ENGINEERING CHANGE NOTICE

Project: Former Satralloy Site Slag Removal Interim Action	ECN No.: 006
Project No.: US0033555.9828	Date: 2/26/2026
Engineering Change Notice Name: South Mill Building Area Grading Revision	Contract No.: 35862100006-001
Project Feature: Plant Area Final Grading, Drainage and Revegetation, Main Access Road Grading	
Affected Documents: Design Drawing Sheets 010, 011, 400-406, 601-603, 605, 610, 612, 613, 620, 630, 802	
Description of Change: Using a similar approach as the one applied to the North Mill Building Area Grading Revision (ECN 005), the final grading surface in the vicinity of the Former South Mill Building was updated to include a minimum 2-foot-thick layer of clean soil fill over existing concrete pads while generally maintaining the original proposed drainage pattern. The resulting changes are presented in Design Drawings Revision 5 - South Mill Building Area Grading Revision and include the following: • The final grading surface was updated to cover existing concrete pads with a minimum 2-foot-thick layer of clean soil fill (Sheets 403-404, 602-603, and 605). Except, the "Mechanic Pad" was left exposed for future use. • MW-07 shall be maintai

PROJECT
FORMER SATRALLOY SITE
SLAG REMOVAL INTERIM ACTION
JEFFERSON COUNTY, OHIO
TITLE
FINAL GRADING PLAN - PLANT AREA (1 OF 2)

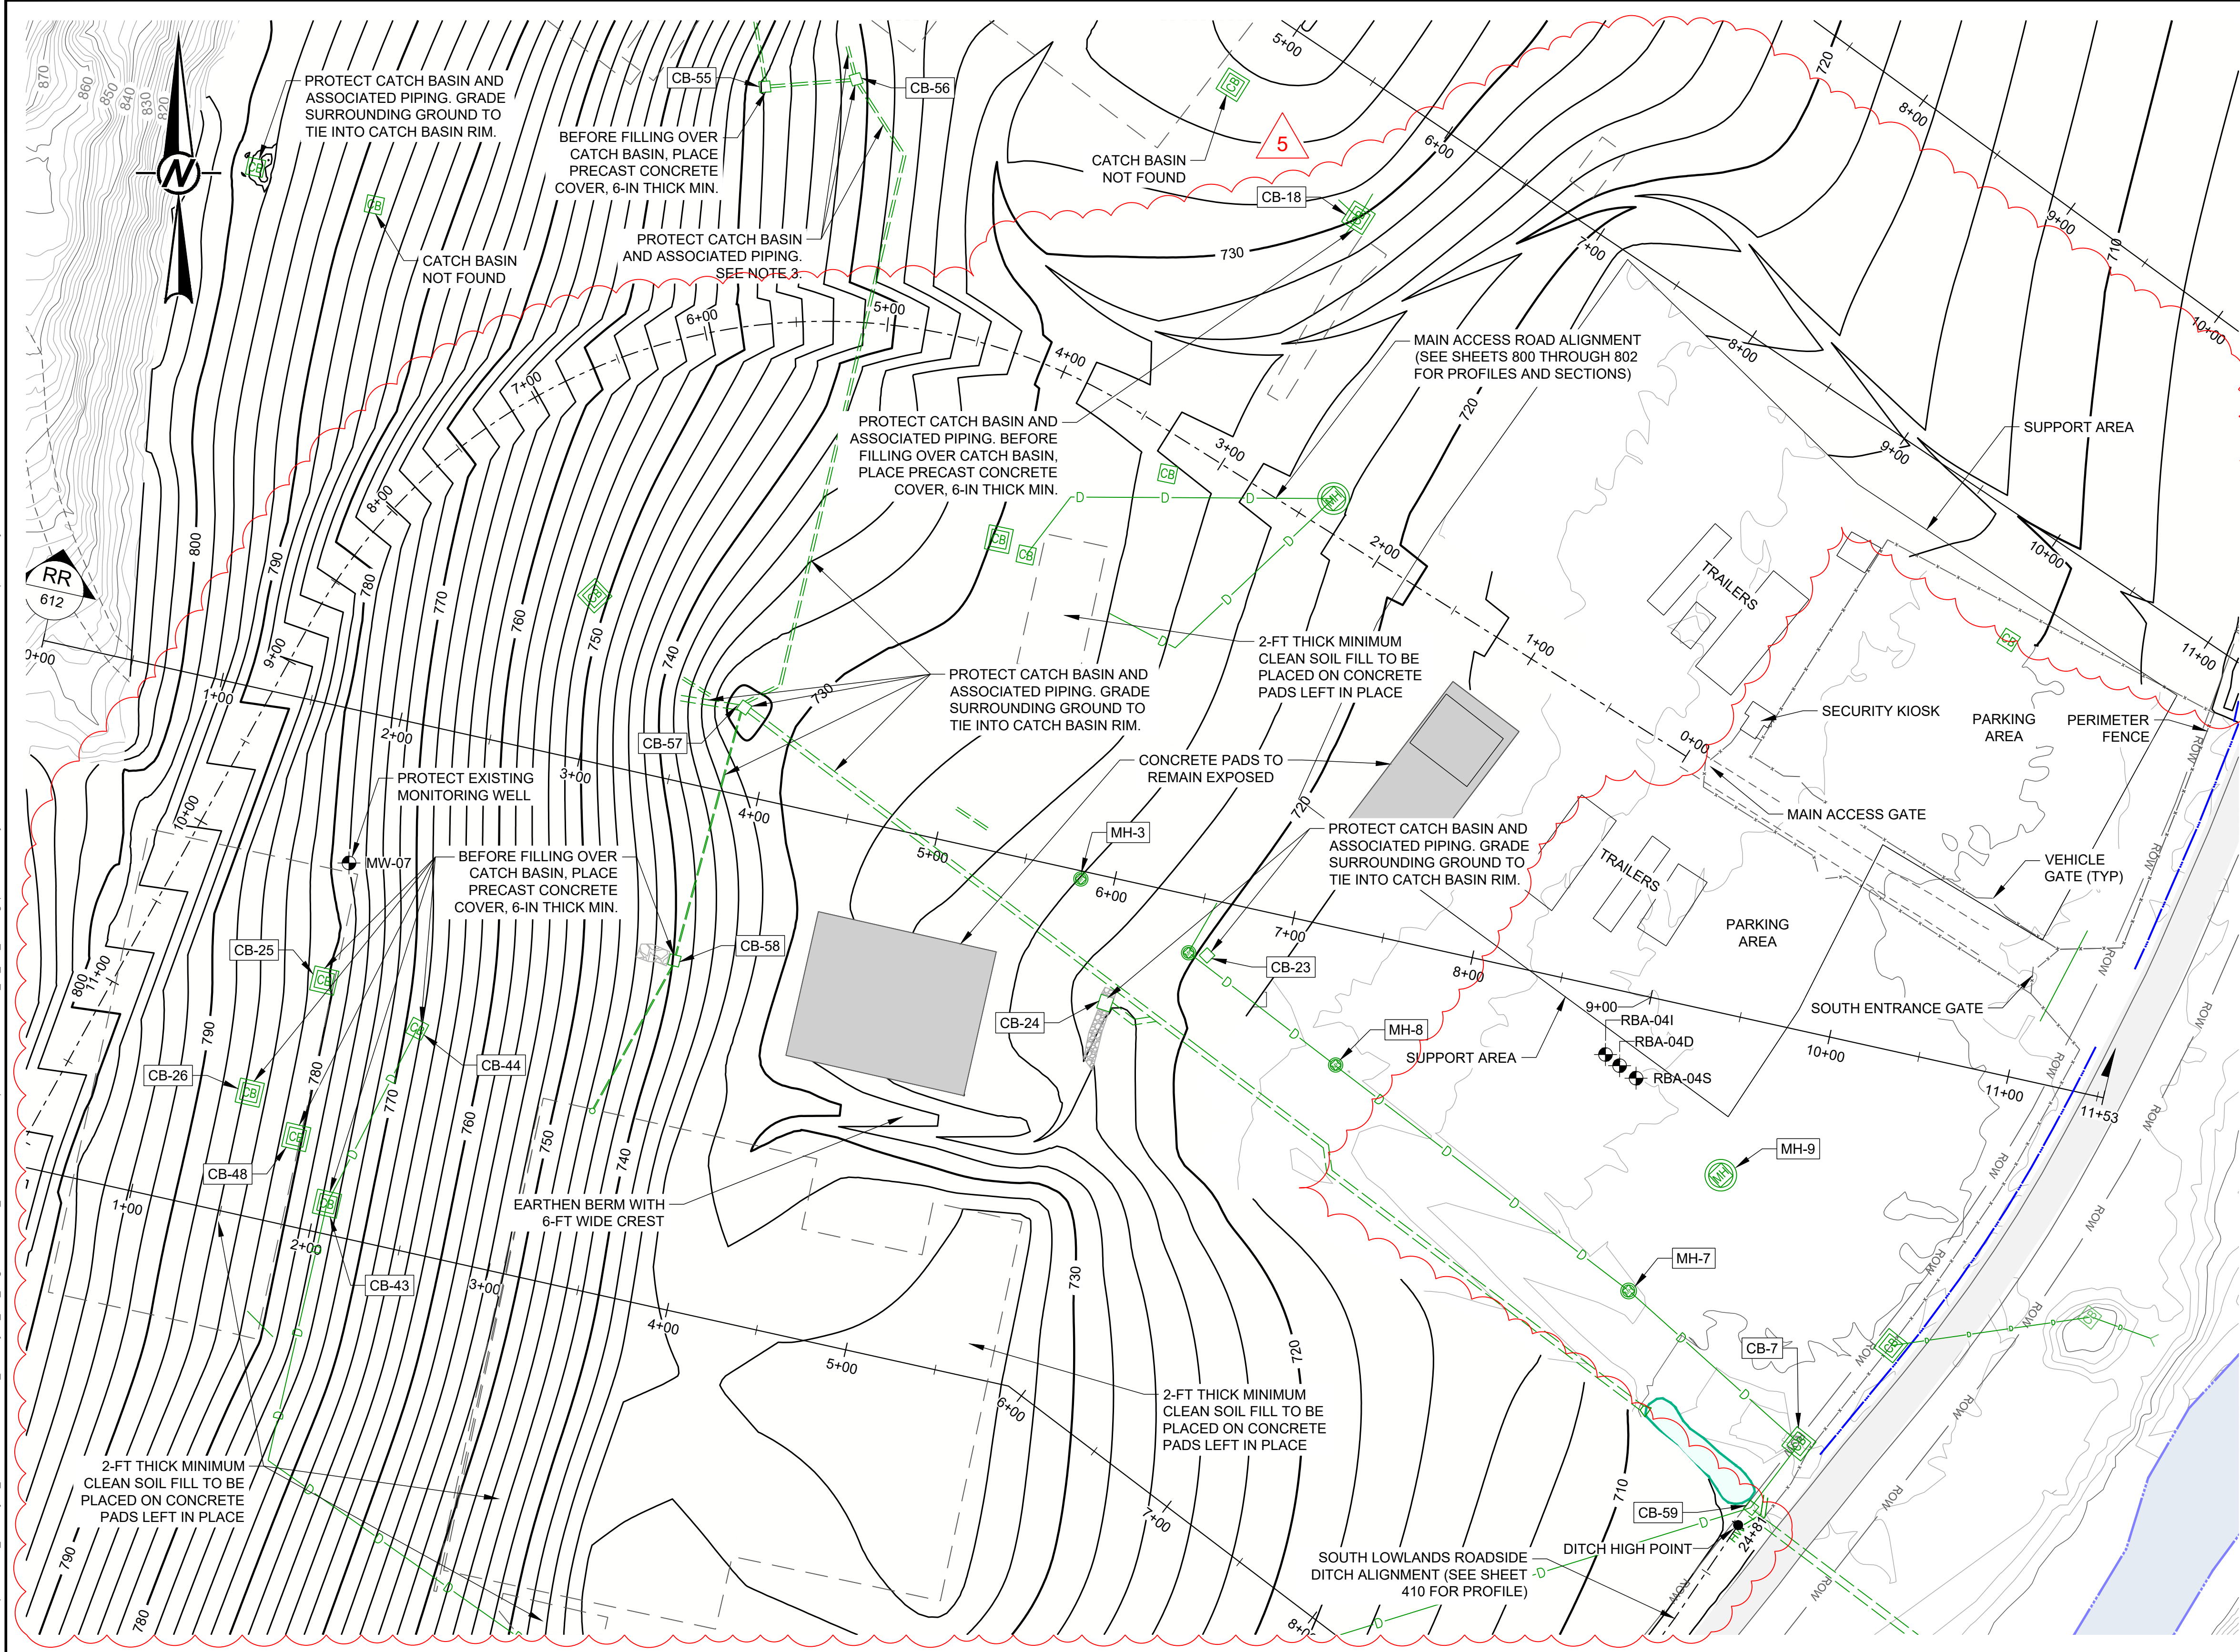
Justification for Change: Originally, the floor between the two main concrete pads of the Former North Mill Building and Former South Mill Building were thought to be composed of soil. The site investigation soil sampling results indicated contaminants of concern within the mill floor soil. Thus, this mill floor soil was proposed to be removed as part of the design. However, during soil excavation in the Former North Mill Building Area, it was found to be underlain by intermittent concrete foundations with varied elevations.

The original proposed drainage pattern assumed that the mill soil floor would be removed, and adjacent concrete pads would remain exposed. However, due to the varied elevations of the concrete foundations found between the two main concrete pads, and because there is a surplus of clean soil fill coming from the Former Mine Area borrow areas, the grading was revised to have a minimum 2-foot-thick layer of clean soil fill over the existing concrete pads in the North Mill Building Area and South Mill Building Area while generally maintaining the original proposed drainage pattern.
